IDWR's May 31, 2012 technical memorandum regarding Sufficiency of Water Supply for Water Right Applications and Transfers along the I-84 Corridor describes a study area and a comparison area as part of their analysis. The study area was established to include all of the new uses proposed by new water right applications for permit and transfers of existing water rights to utilize ground water from a new area. The study area is described as patterned after a 1981 study by IDWR in conjunction with creating the CCBCGWA.

REVIEW OF IDWR'S MAY 31, 2012 STAFF REPORT

Response to SPF's Memorandum Entitled "Response to IDWR Staff Memo Regarding the Sufficiency of Water Supply For Water Right Applications and Transfers Along the I-84 Corridor," November 15, 2012

Figure 2

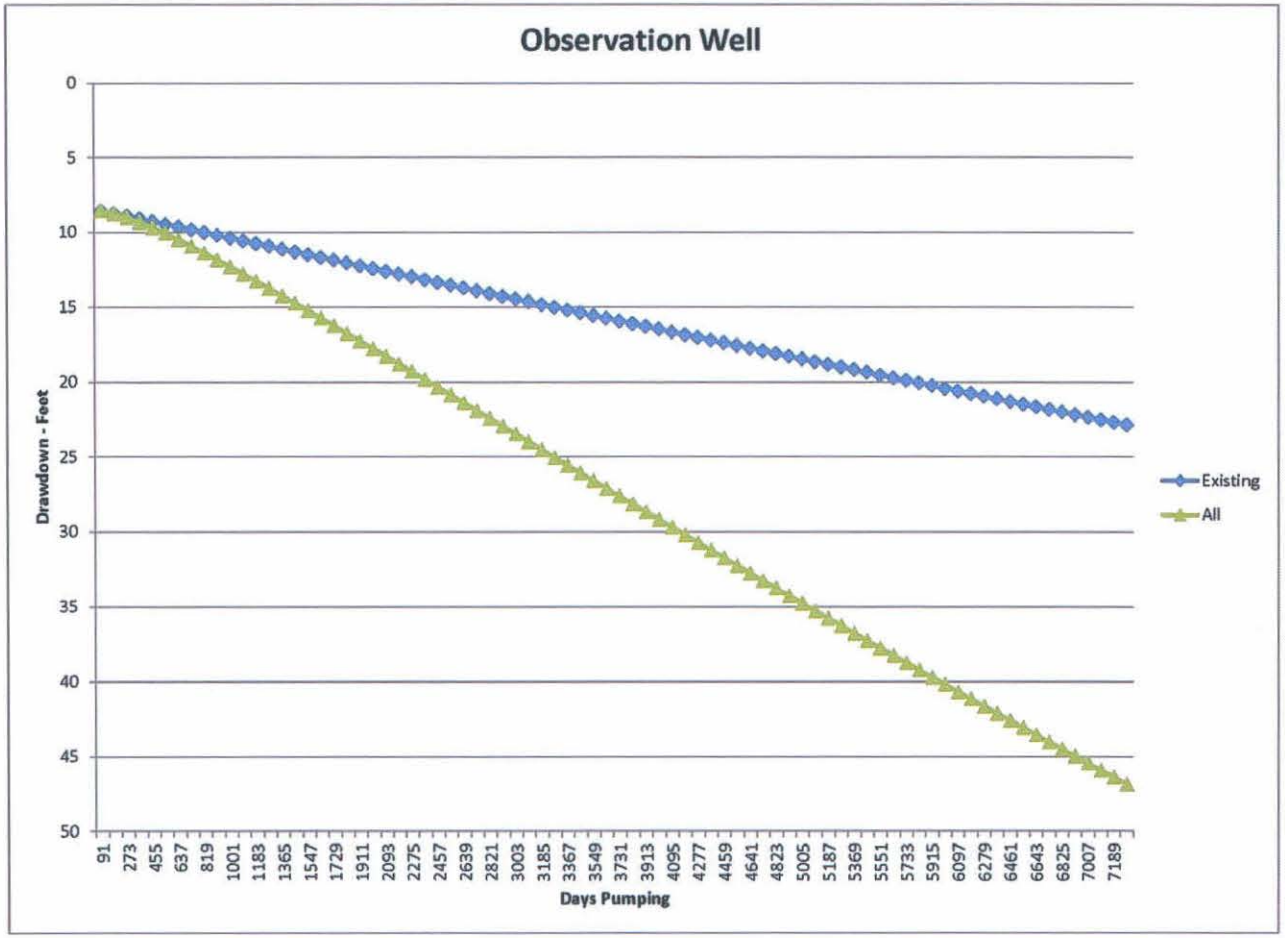
To estimate the impact of continued pumping by existing water users the program was run for an additional 20 years. A simulated observation well was placed near the center of Sec 19 Twp 1S Rge 5E, B.M. which is near the location of the fault identified by Bond and near the boundary of the study area and the comparison area[2]. The results of the additional simulated pumping are shown in Figure 2 below. The analysis shows an estimated drawdown at this location of about 8 feet after 20 years of pumping the existing wells. When pumping of those wells continued for the second 20 years the analysis shows an increased rate of drawdown of about 15 feet for a total drawdown of about 23 feet by existing water uses after 40 years of pumping.

The existing permits, transfers and new water right applications were then added to the analysis and the second 20 year simulation was run a second time. The projected drawdown is shown on Figure 2 below as "All" and shows a drawdown of about 47 feet in the second 20 years, about double the drawdown that is forecast if existing conditions remain unchanged.

Recognizing the Theis analysis is a simplification of the actual conditions that may exist in both the study area and the comparison area, it does point to the potential interconnection between the two areas. Such an interconnection could cause some of the net recharge IDWR identified in the study area to not be available for future appropriations because it is part of the interconnected supply already being used by existing ground water users. It also shows the potential for any new water uses in the

Figure 3

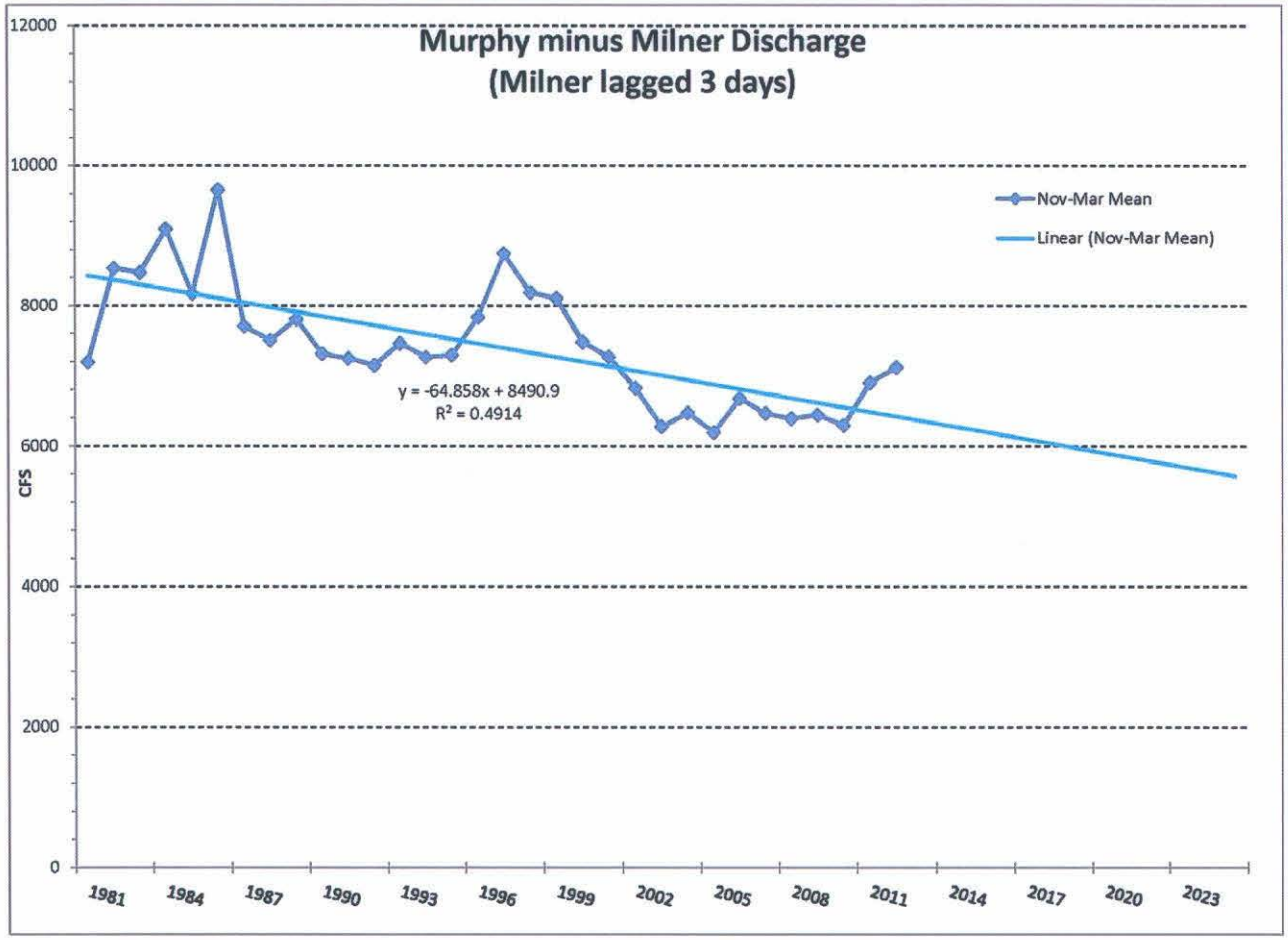
Figures 3 and 4 below were produced using mean daily flows for Murphy and Milner, modified as described above, and averaged for the winter and summer periods respectively. Figure 3 suggests the average mean daily winter discharge at Murphy, as modified above, has declined about 2,000 cfs since 1981 and is continuing to decline at about 65 cfs per year. Projecting this rate of decline forward from 2012 for 13 years suggests the average mean daily flow for the winter of 2025 will be 5,600 cfs, the winter minimum flow established by the Swan Falls Agreement and approved by the Idaho Legislature.

Figure 4

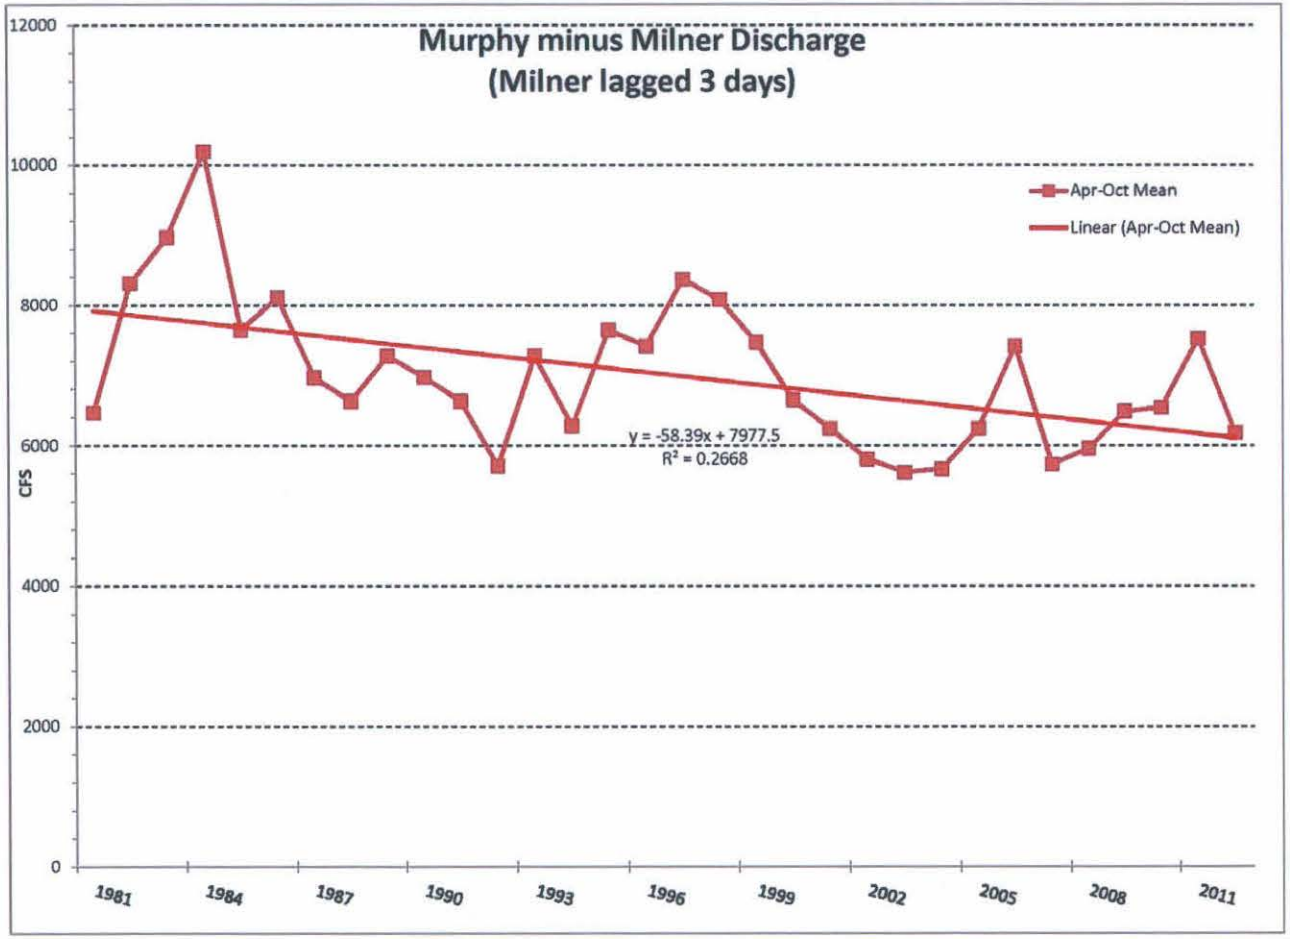
Figure 4 suggests the average mean daily summer discharge at Murphy, as modified above, has declined about 1,850 cfs since 1981 and is continuing to decline at about 58 cfs per year. The average summer flows are still high enough there is no immediate danger the entire average summer flow will decline to 3,900 cfs, the summer minimum flow established by the Swan Falls Agreement and approved by the legislature. Summer flows are, however, quite variable, and time periods shorter than the 7 months from April through October were examined to determine if one period was consistently lower than the entire summer period. To perform that analysis, monthly averages of mean daily summer flows at Murphy, as modified, were calculated for the months April through September with the lowest month being July.

Figure 5

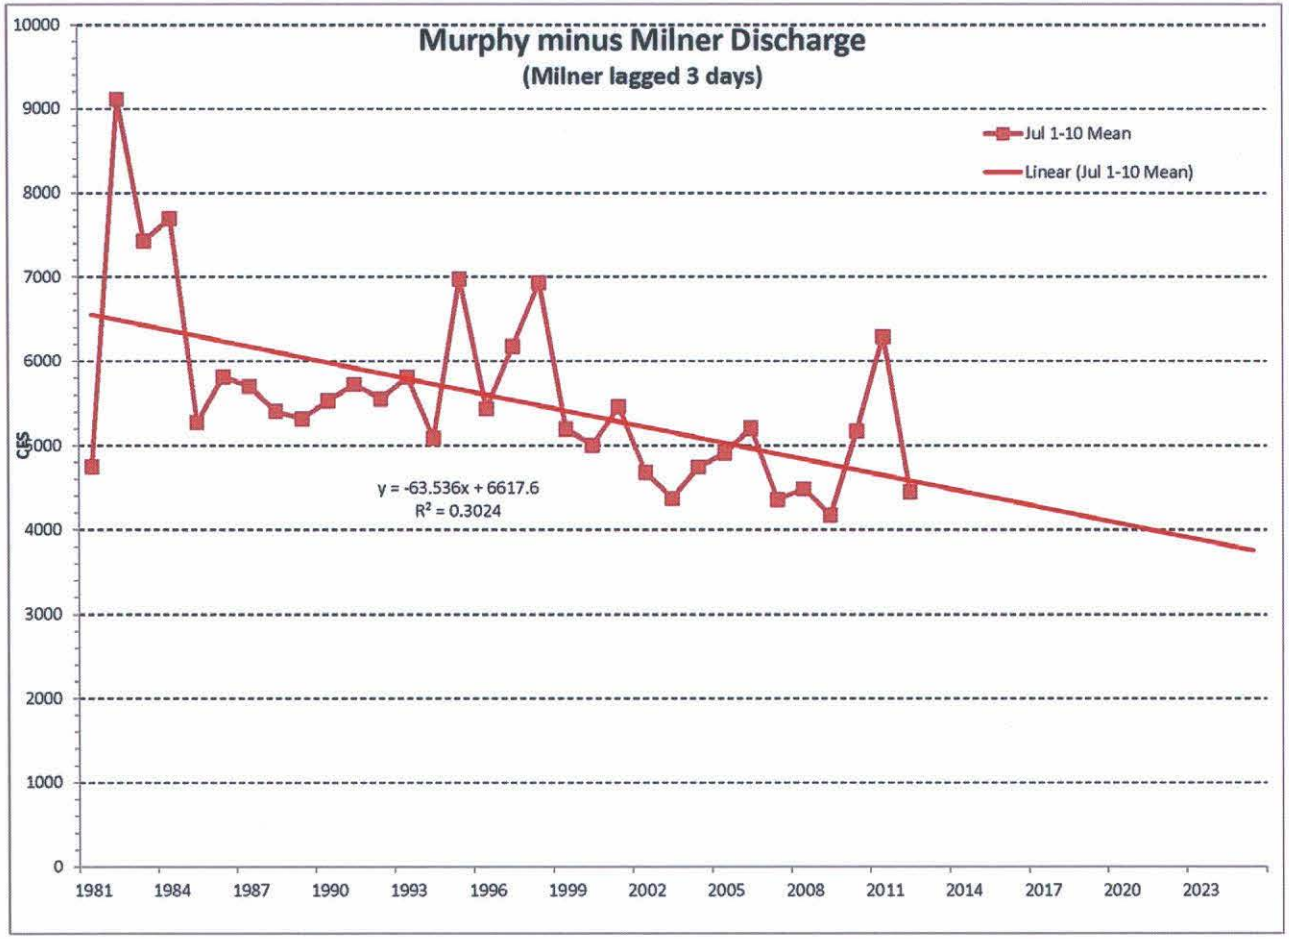
A 3 day lag time produced reasonable results on a monthly or longer basis but when shorter time periods are examined using a 3 day lag time does not produce consistent results. Some trials were completed using varying time periods and 10 days was selected as a compromise to minimize the effects of varying lag times and actual low flows masked by using mean daily flows averaged over a longer time period.[4] Several 10 day periods were tested in July and the 10 day period with the lowest average mean daily flows, as modified, was determined to be from July 1 through July 10 of each year. The result of the analysis is shown on Figure 5 below. The average of the mean daily flows for the July 1 – 10 period is shown to have declined over 2,000 cfs for the 1981 through 2012 period. The linear trend for that period shows a decline of about 63 cfs per year, on average and the linear trend line goes below 3,900 cfs prior to 2025.
